From: Scala, Mary Joy
Sent: Thursday, October 27, 2016 3:29 PM
To: Gerry Starsia (gstarsia@gmail.com)
Cc: Hiatt, Jean
Subject: BAR Actions - 401 Altamont Circle - October 18, 2016

RE: Certificate of Appropriateness Application
BAR 16-10-04
401 Altamont Circle
Tax Parcel 330111000
Marianne and Gerry Starsia, Owner/Applicant
Demolish Porch or restore balcony

**CITY OF CHARLOTTESVILLE
BOARD OF ARCHITECTURAL REVIEW
STAFF REPORT
October 18, 2016**

BAR 16-10-04

Proposed Porch Alteration

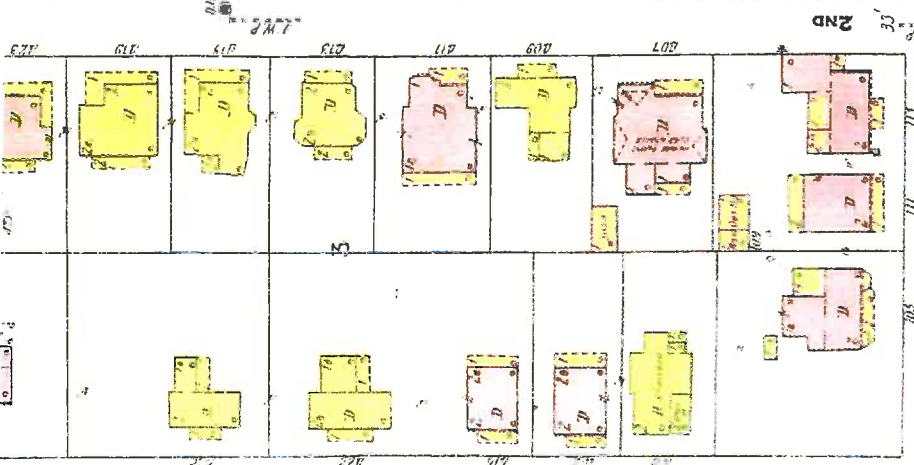
The balcony structure was added sometime between 1910 when the house was built, and 1956, when the stairs were added. Although the curved stairs are now 60 years old, there is merit in removing them and restoring the porch to a balcony to resemble its pre-1956 appearance with a triple-hung window. It would not be appropriate to demolish the balcony structure entirely because it contributes to the character of the house.

Schwarz moved to approve Option A to restore the porch to a balcony, as submitted, with the provision that Preservation Piedmont can come to document the stairs, and the BAR approves the removal of the walnut tree. Balut seconded. Motion passes 7-1 with Miller opposed.
